COUNCIL ASSESSMENT REPORT NORTHERN REGIONAL PLANNING PANEL

PANEL REFERENCE & DA NUMBER	PPSNTH- 404 DA25/0011
PROPOSAL	Staged 217 lot residential subdivision, with conservation lot and associated civil works and vegetation removal, environmental facility, recreation areas and environmental protection works (NRPP)
ADDRESS	Lot 13 DP 1264394; Henry Lawson Drive TERRANORA; Lot 3 DP 622318; No. 127-137 Mahers Lane TERRANORA
APPLICANT	Zone Planning NSW Pty Ltd
OWNER	Mahers Lane Developments Pty Ltd
DA LODGEMENT DATE	8 January 2025
APPLICATION TYPE	Development Application
REGIONALLY SIGNIFICANT CRITERIA	<p>Section 2.19(1) and Clause 2 of Schedule 6 of <i>State Environmental Planning Policy (Planning Systems) 2021</i> declares the proposal regionally significant development as:</p> <p>3 General development over \$30 million</p> <p><i>Development that has an estimated development cost of more than \$30 million.</i></p>
CIV	\$36,387,252.50 (excluding GST)
CLAUSE 4.6 REQUESTS	NIL

SCHEDULED MEETING DATE	20 August 2025
PLAN VERSION	As originally submitted
PREPARED BY	Hannah Van de Werff
DATE OF REPORT	7 August 2025

Figure 1: Site Specific Section B1 TDCP2008 - Terranora Locality Plan and proposed plan of subdivision overlaid (yellow highlight extent of urban footprint not catered for in Locality Plan).

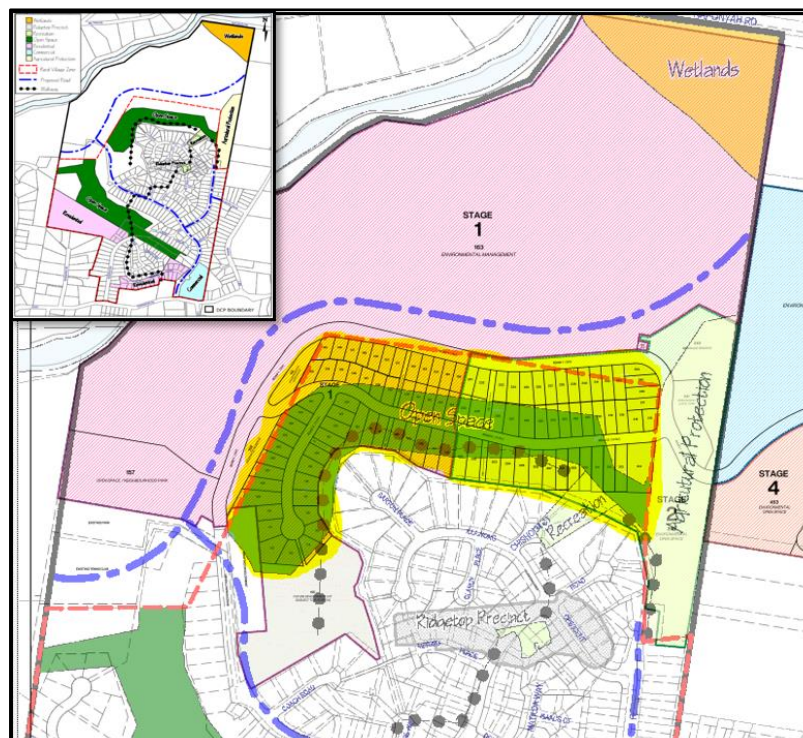
The site is accessible from the existing road network via Mahers Lane and Henry Lawson Drive. Henry Lawson Drive is defined as a sub-arterial road with an approximately 8.5m wide carriageway. Mahers Lane is a collector road with an approximately 7.5m wide carriageway. Both roads are currently no through roads under the control of Tweed Shire Council. The adjacent major intersections of the proposed development are the Terranora Road/Henry Lawson Drive Intersection and the Terranora Road/Mahers Lane Intersection. Both intersections are priority controlled intersections. In terms of future development, the construction of the Broadwater Parkway is planned to connect Fraser Drive and Mahers Lane, serving as a central transportation corridor within Terranora Area E (refer to future “proposed road” to the north of the subject site highlighted in blue in **Figure 1** below).

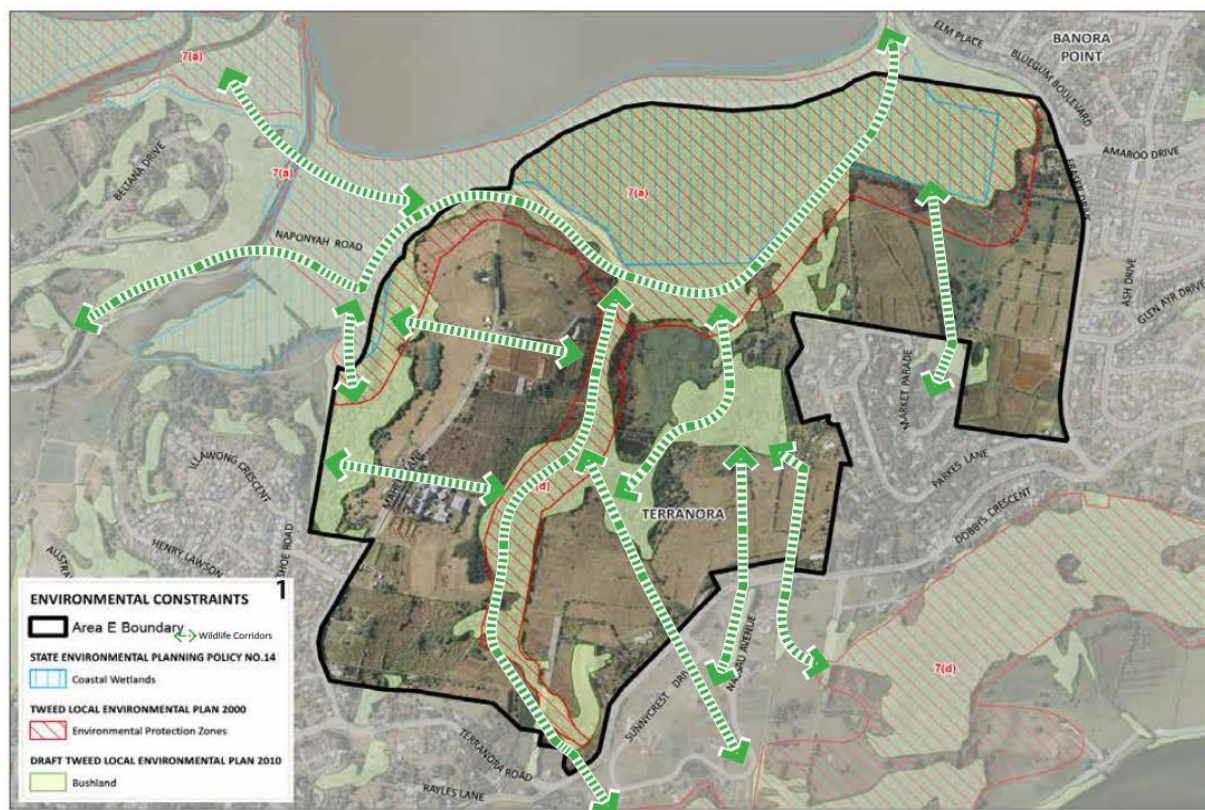
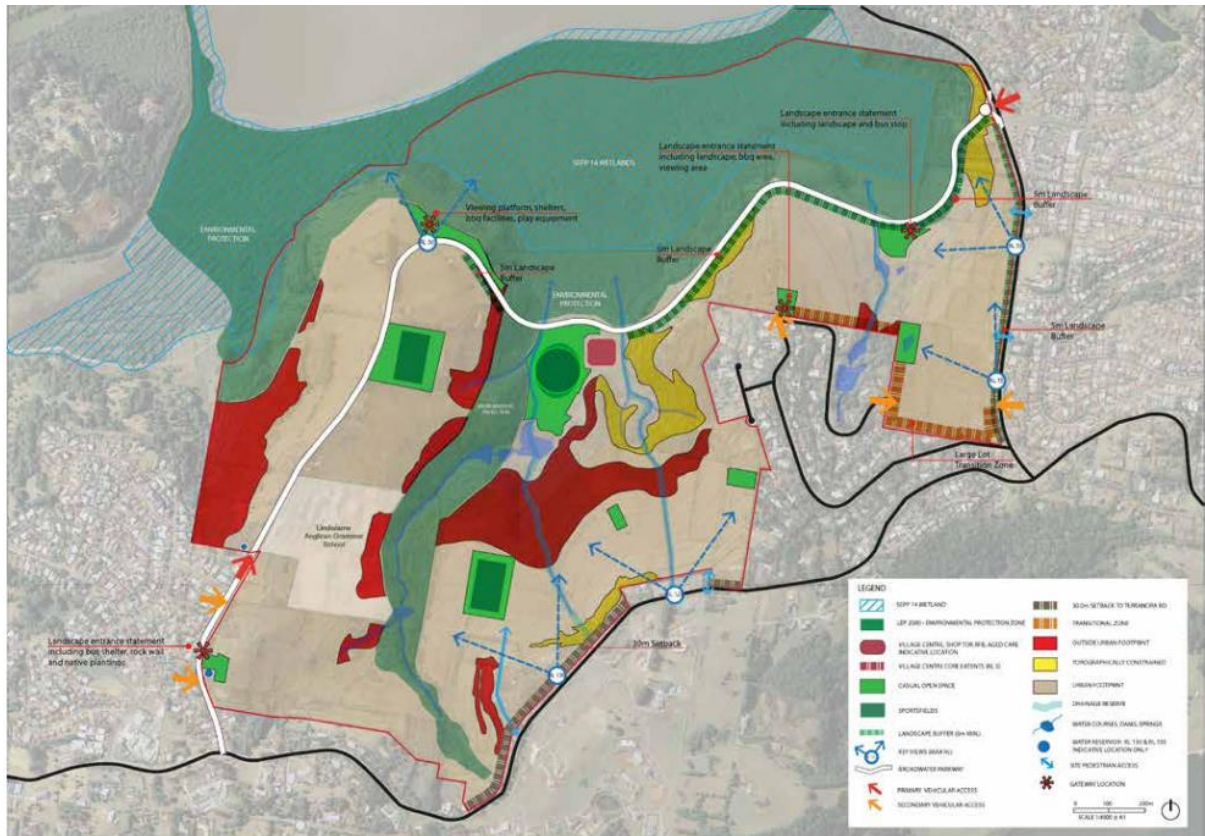
The proposed development envelope appears to extend outside the urban footprint identified in Figure 2.1 of Section B1 of the DCP and appears to extend into areas of 'Bushland' shown in Figure 2.3.

Figure 2.5 - Visual Catchment of Area E and Key Public Vantage Points

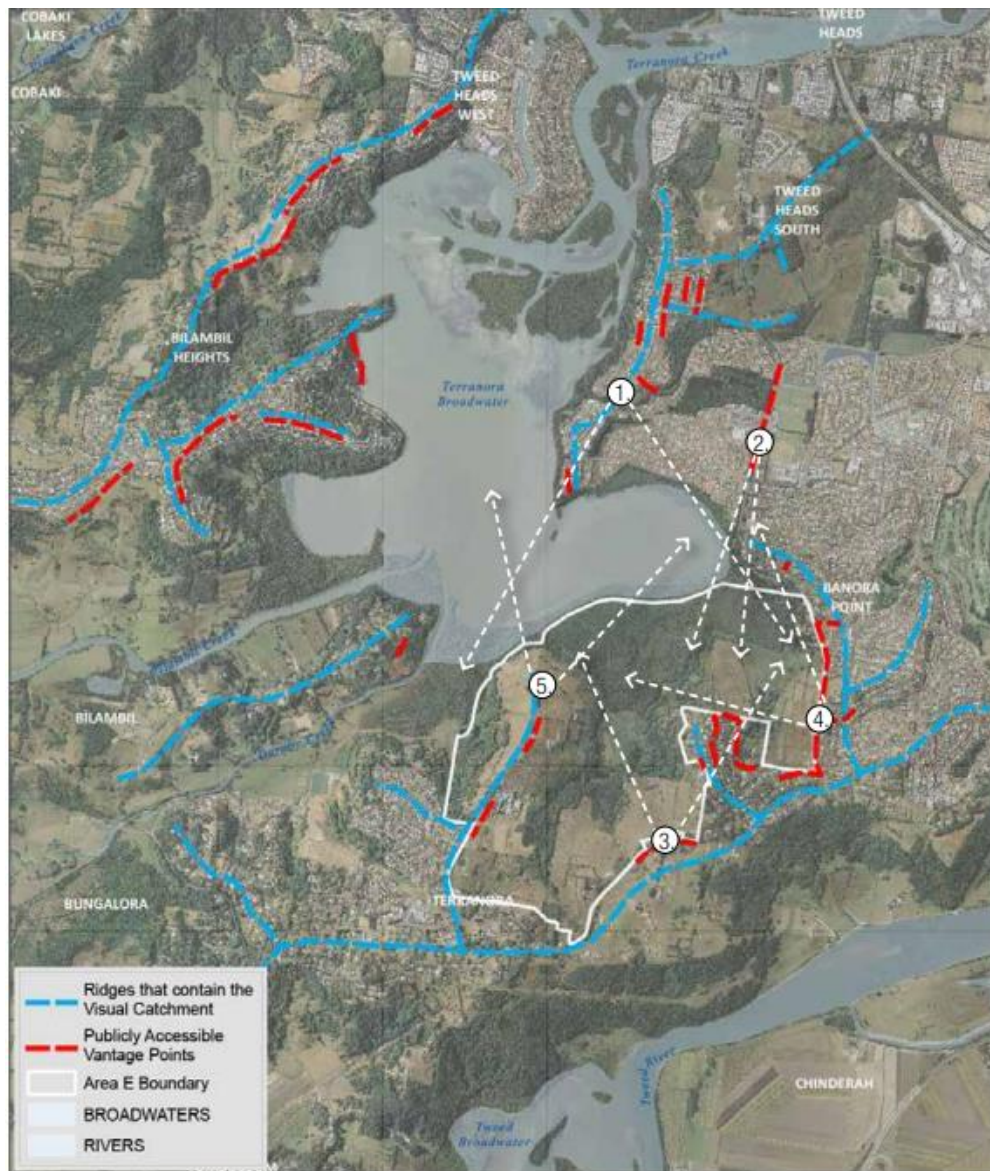
- It is unclear as to whether the proposal obstructs view lines as identified in the 5 key views illustrated at Figure 2.5. This is particularly relevant for the ridgeline at which an open space greenbelt was provided in the B1 Locality Plan and is proposed to be replaced with a residential urban footprint.

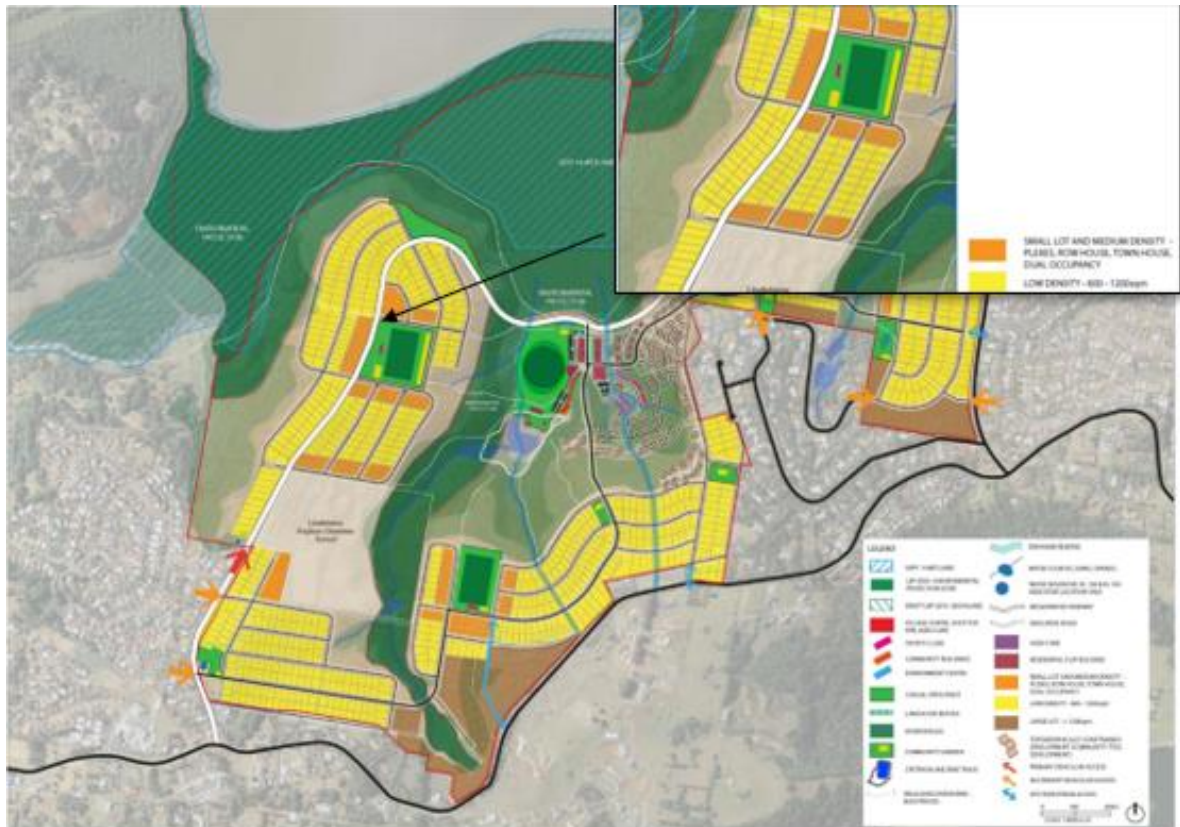
The proposed lot layout fails to acknowledge the above dwelling density requirements. Lots in this location comprise of standard residential lots capable of supporting a single dwelling only. In order to achieve the desirable housing type in this location, larger lots would need to be afforded to this location, enabling integrated housing in the future.

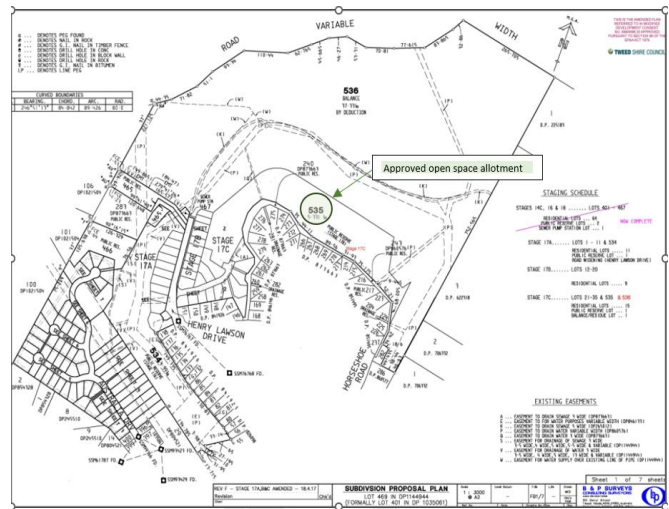
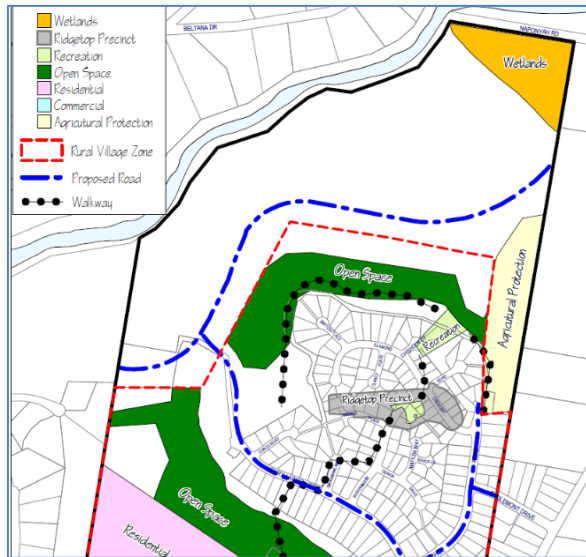
However, in addition to the above, Council officers have identified discrepancies in the recommendations of the Bushfire Report and the submitted plans in terms of bushfire protection measures according to the staging. Further, the ecological value of the land (see biodiversity key issues below) would likely give rise to adverse impact in creating “No fuel Zones” and APZ's which extend beyond the outer kerb of the perimeter roads.

Tweed Shire Council has a policy which restricts fuel reduced area on Council owned or managed land (see *Asset Protection Zones on Public Land Version 1.4, Adopted by Council on 3 December 2020*). In the absence of the performance solution being accepted by Council and the consent authority, the development cannot achieve compliance with Condition 1 in the General Terms of Approval in the Bushfire Safety Authority issued by NSW RFS.

Proposed Open Space Location:

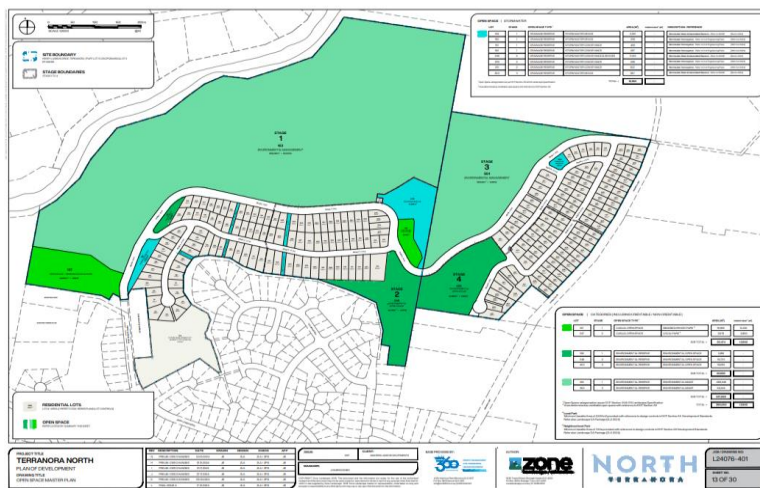
Whilst there is some merit to support the relocation to expand the existing structured open space to the western extent of the site, the higher order issues in relation to the proposed urban footprint and the impact on natural environment, variations to the DCP, lack of information (i.e. a comparative analysis study of open space alternatives having regard for the ecological values of the area currently identified as Open Space in the DCP B1 (to the south of the site) has not been provided, visual impacts having regard to the values of the site and surrounds have not been properly considered to determine the impact of the proposed urban footprint having regard to the existing consent and anticipated "Green Belt" per the Structure Plan in Section B1 TDCP2008.

Finally, given the history of the site, there is community expectation that the “green belt” of open space would run along the rear of the proposed residential lots previously approved under the historic consents. Council has received many submissions in this regard in which the consensus is that such should not be allowed based on previous court decisions.
